System level Discussion

Project: IEEE P802.3dm - ISAAC

Event: ISAAC Use Case AdHoc Call

IEEE P802.3dm Task Force - ISAAC

MT comments on houck_fuller_3dm_01_0724.pdf p. 4/5

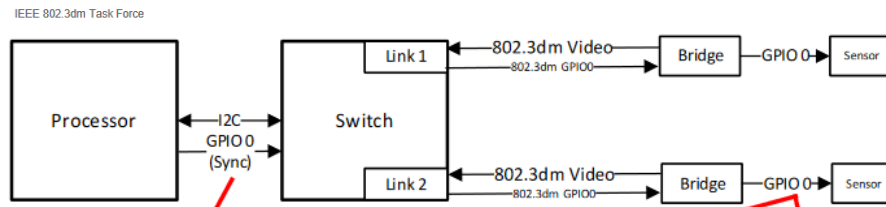
- Start-up time should NOT be mixed with Latency or Delay of the data transport
- We should agree on defined terminology in order to prevent misunderstanding:
 - Start up time
 - Image frame transfer latency
 - Ethernet frame latency
 - PHY delay
 - Link delay
 - ...

MT ideas on the use of the “Delay” and “Latency” suffixes

- ‘something’ Delay: “first bit to first bit”
 - Time interval between the (first bit of the) SFD (or any other defined bit) of two packets to pass a certain reference plane
 - Time interval for a certain specified bit within a packet to pass from one reference plane to another reference plane
 - **Does NOT depend on packet length!** i.e. not dominated by line rate
- ‘something’ Latency: “first bit to last bit”
 - Time interval between the (first bit of the) SFD and the (last bit of the) FCS of a certain packet to pass a certain reference plane
 - Time interval between the (first bit of the) SFD of one packet and the (last bit of the) FCS of a response packet to pass a certain reference plane
 - **Depends on packet length!** i.e. dominated by line rate at least for large packets
- More detailed proposal later in the presentation

page 7

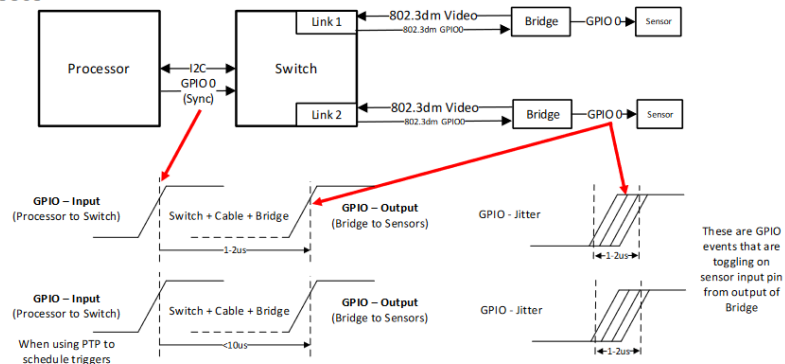
MT questions:

- Can we add a reference for each of those requirements on page 6?
- Can we find terms (Bridge, Switch) which are not already overloaded in the 802.1 realm?

Latency and Jitter Application Diagram

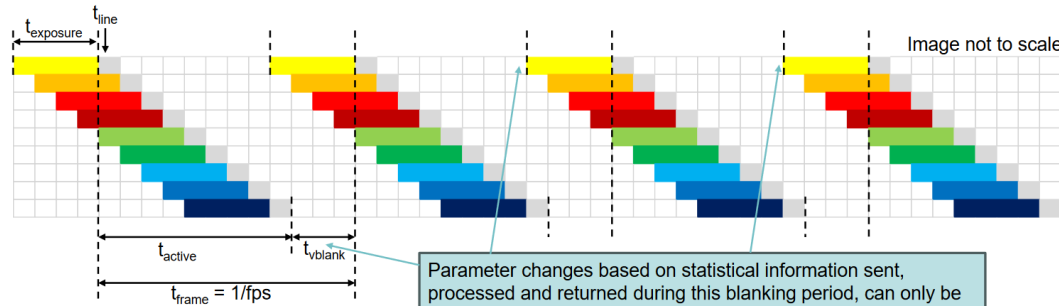
MT questions:

- Does this implicitly restrict the topology to a single MDI to MDI link?
- The GPIO-Jitter looks like an application layer problem, not a network problem
